## Verification Report

008

McAlear & Rushe

AREA SURVEYED: East Toe Detail - South Toe Detail

## VERIFICATION LAYOUT

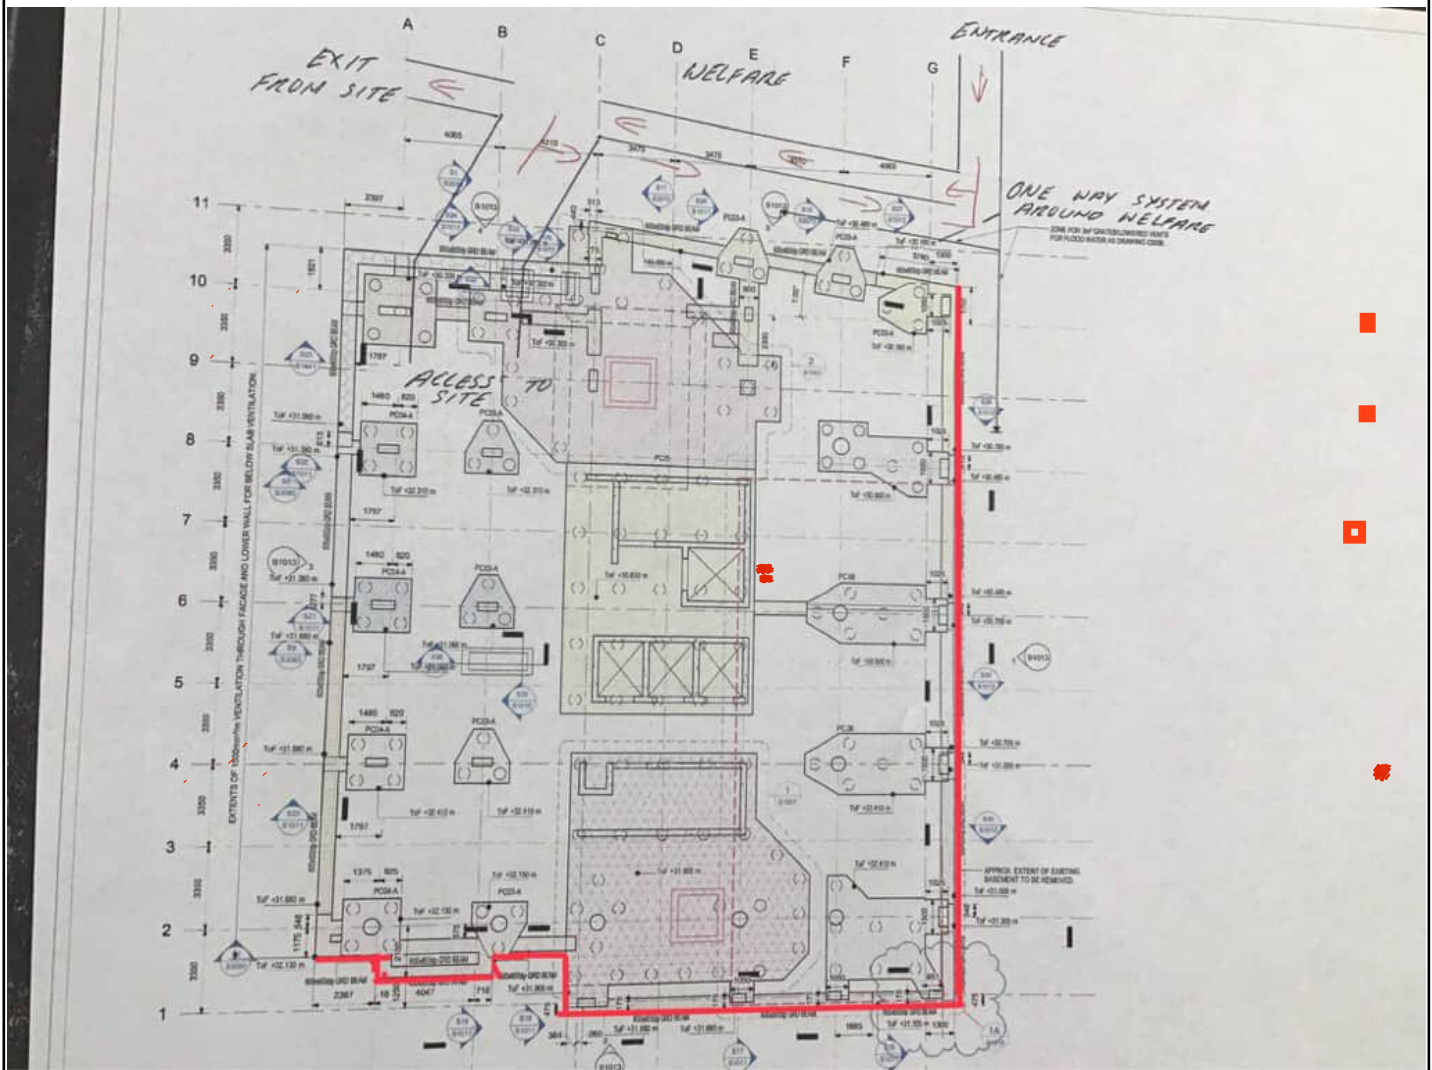
Area highlighted East and South Toe Detail

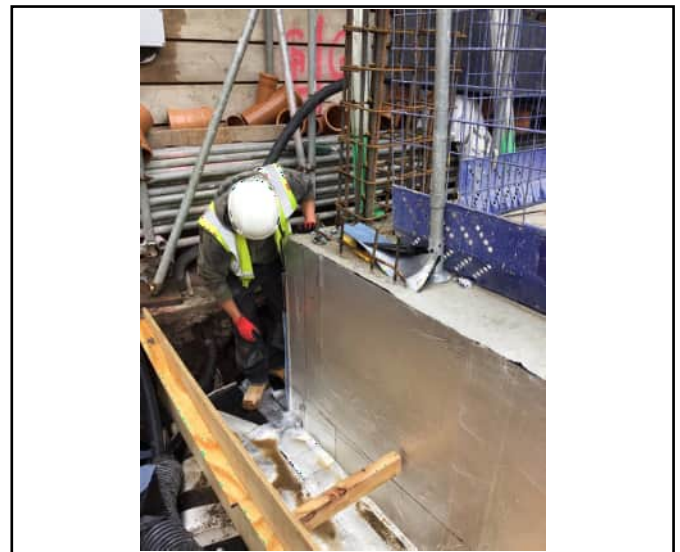
Primed concrete wall on

Eastern Toe
